Structural Technical Advisory Committee – Comments

9th Edition (2026) Florida Building Code, Building

CHAPTER 22 STEEL

Fig. 2 (Impactor Design)

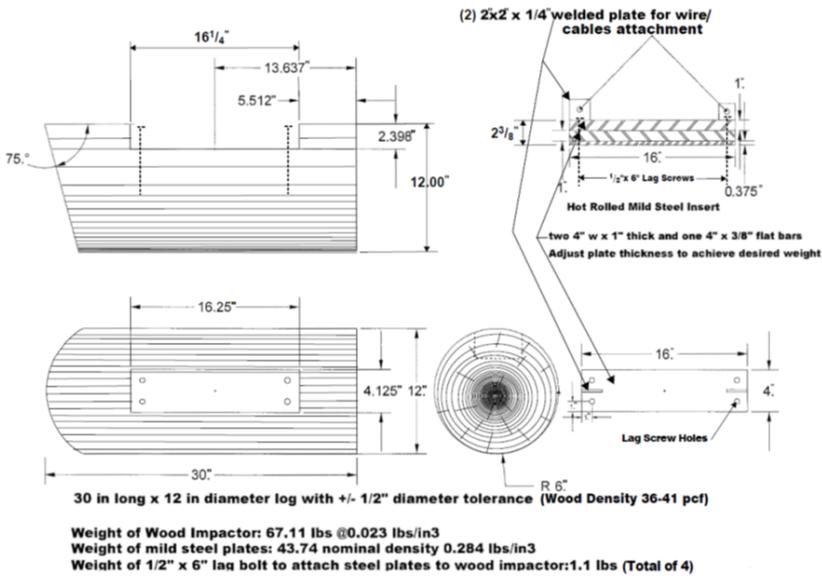
Pursuant to the draft for new test protocol TAS204 as posted on last page at [Supplement to the 2023 Test Protocols for HVHZ.docx](#), there should be two figures at the end of the protocol on pages 5 and 6 as shown in the attached file and in the BCIS for this MOD.

TAC Recommendation: Editorial – AS [11-0]

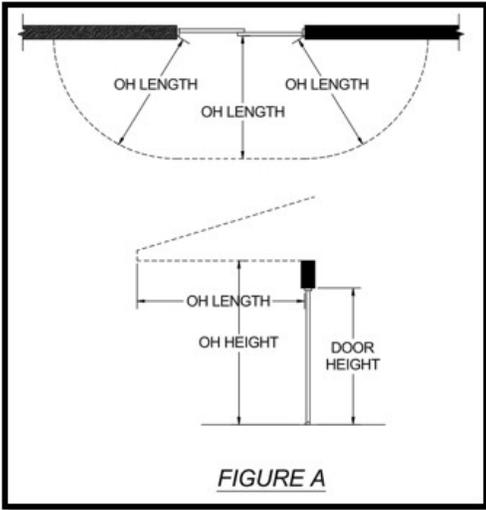
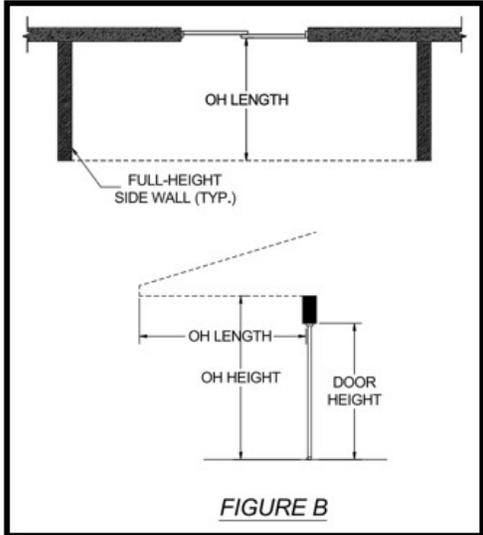
The original proposals as well as the modified proposals that were ultimately adopted by the Structural TAC and Commission, never included section 1709.5.2. This section provides for exterior side-hinged doors. The correlation issue is that the pointer to 1709.5.2 only exists in 1709.5.1, and not 2411.3.2.1. This alternate language attempts to rectify that to ensure consistency for code users, whether they are using the Chapter 17 or Chapter 24 provisions.

Changes in RED are the new alternative language to align section 2411.3.2.1 with 1709.5.1. Remaining changes simply reflect what was already adopted for the 9th edition.

OH length = The horizontal measure of how far an overhang over a door projects out from door surface as shown in Figure A. Where the overhang extends to side walls on both sides of the door that have a height equal to the overhang height, the OH length is as shown in Figure B.

TAC Recommendation: Correlation – AS [1-10] Fails
